Report to Planning and Environment Committee

Subject: York Development

131 King Street

Public Participation Meeting on: November 12, 2018

Figure 1 – West Elevation

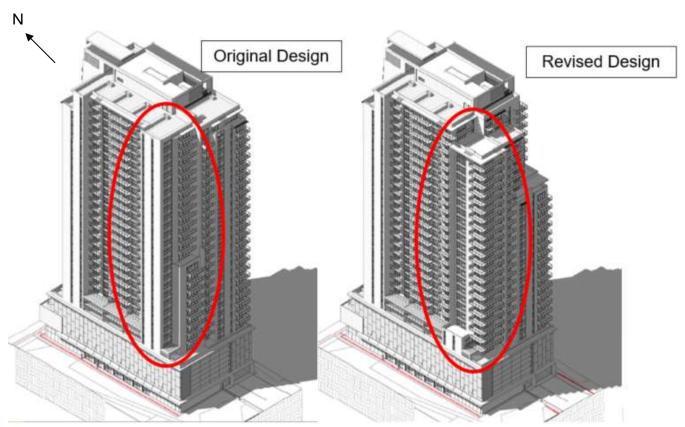
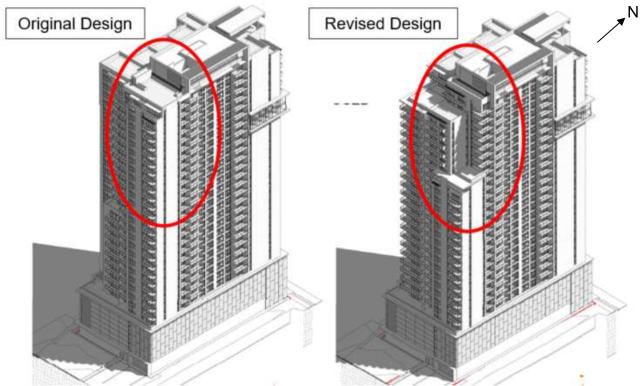
but had some concerns with the visual massing of the building due to the length of the building along the north/south axis. It was recommended that the width of the building be reduced at the top portion to help reduce its overall visual massing and scale. There was also a recommendation to break down the mass of east and west sides of the building through additional articulation and separating of the balconies.

The applicant refined the design and was able to reduce the massing on the south side of the building by reducing floors and adding an additional setback on the west side of the building which allows for the removal of the large blank column on the wall and introduction of additional balconies and glazing to soften the view from the west (see fig 1). The south east corner has seen significant reduction in height as well to help reduce the visual massing of the structure (see fig 2). In keeping with direction from Staff and the Panel the balconies on the east and west sides of the building were redesigned in a manner that helps break down the visual massing and length on these sides of the building. The breaking up of the balconies also provided the opportunity to introduce additional glazing to the project resulting in the final design which is attached to the recommended By-law as Schedule "1".

Figure 1: Stepback Diagram (SK-07) from the Urban Design Brief for 131 King Street.

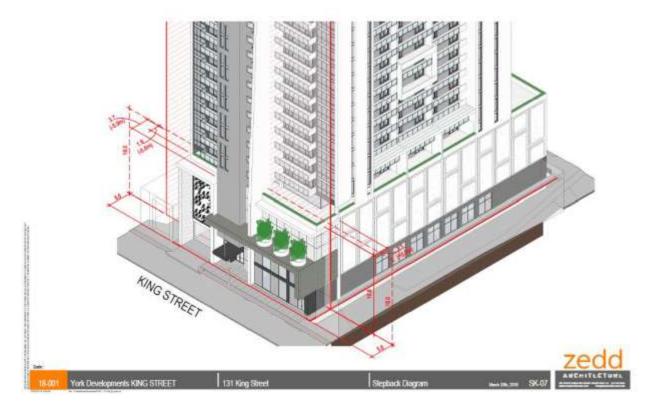
- Stepback The proposed development does not comply with the 5m stepback above the 18m height of the podium (Section 6.1.4.1, Façade Composition, Downtown Heritage Conservation District Plan, p.6.41). The Heritage Impact Assessment rationalization for a deviation from the required 5m stepback:
 The building provides setbacks above the podium level, but in an attempt for a more sculptural building quality, the setbacks vary from 3 metres to 8 metres as opposed to the 5 meter recommendation. This approach allows the

While not included within the Heritage Impact Assessment, the Stepback Diagram (SK-07) included within the Urban Design Brief more clearly articulates the stepbacks of the proposed development. The "tongue" feature of the proposed development projects into the 5m stepback. To achieve the required 5m stepback, opportunities to adjust the "tongue" of the proposed development to comply with the 5m stepback requirement of the Downtown Heritage Conservation District Plan should be undertaken.
